## APPEAL SUMMARY

**Status:** Decision Rendered**Appeal ID:** 15833**Project Address:** 817 SW 17th Ave**Hearing Date:** 9/13/17**Appellant Name:** Michelle Schulz**Case No.:** B-016**Appellant Phone:** 503-548-2379**Appeal Type:** Building**Plans Examiner/Inspector:** Kathy Aulwes**Project Type:** commercial**Stories:** 9 **Occupancy:** B, M, A **Construction Type:** 1-B**Building/Business Name:** Press Blocks - Half Block Office**Fire Sprinklers:** Yes - Throughout**Appeal Involves:** Erection of a new structure**LUR or Permit Application No.:** 17-182179-CO**Plan Submitted Option:** pdf [File 1] [File 2] [File 3]**Proposed use:** Office with ground level retail

Opening Protectives  
Appeal

EXHIBIT A-1

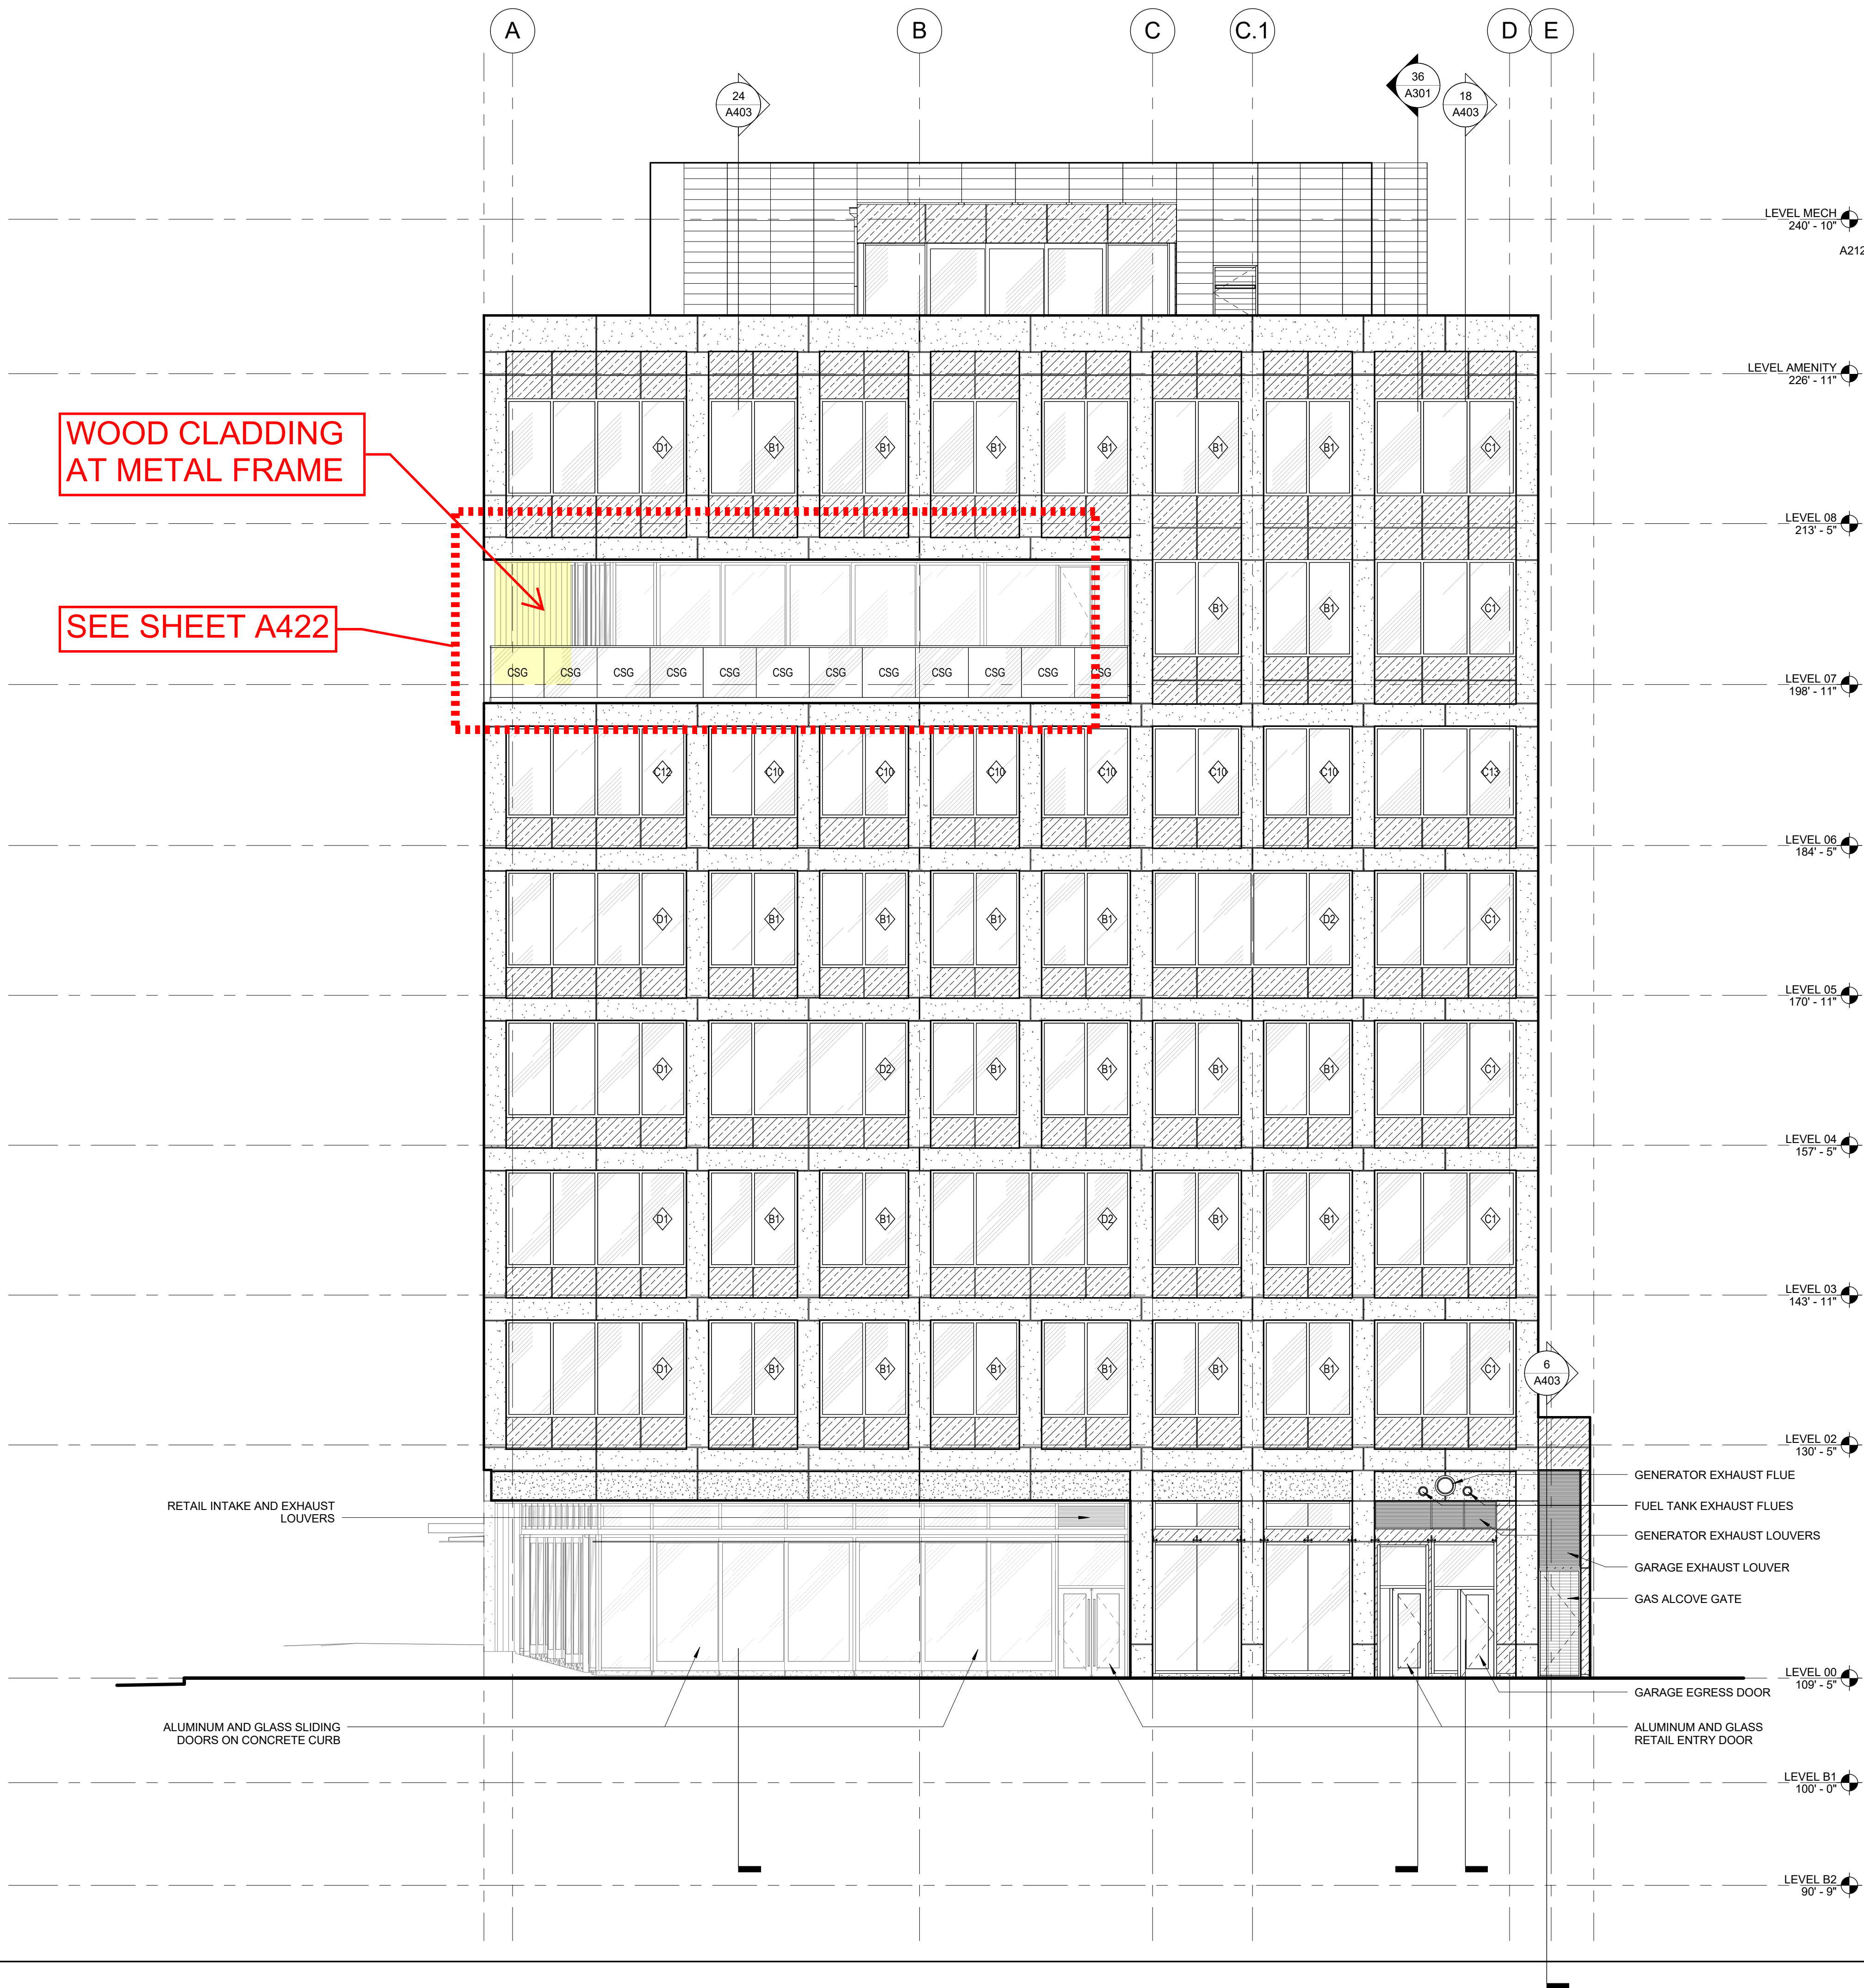
**Proposed Design** The proposed design utilizes FSC certified 1x6 tropical hardwood (Cumaru) as exterior siding at one location on the 7th floor at an exterior terrace. The total area of wood is approximately 199 SF. The wood siding is mounted on fiberglass or galvanized steel Z- furring which is mounted on one layer of exterior gypsum sheathing (Densglass or equivalent) to form a rainscreen. Mineral wool takes up a 2" of a 2 ½" cavity behind the wood siding. The exterior wall assembly is non-combustible throughout.

**Reason for alternative** The wood is included at the 7th floor location for architectural design reasons and creates visual continuity with recessed wood siding located below on the ground level entry. Creating an architecturally significant element requested by the Design Commission in our Design Review process.

We contend that due to the metal framing, one layer of exterior gypsum sheathing, fiberglass furring, mineral wool insulation and extremely low flame spread rating of the Cumaru hardwood siding material the assembly meets requirements for non-combustible construction.

**3. Cumaru tropical wood Class A cladding at exterior 7th floor amenity space: Granted provided open flame devices are located with a minimum of ten feet separation from the wood cladding.**
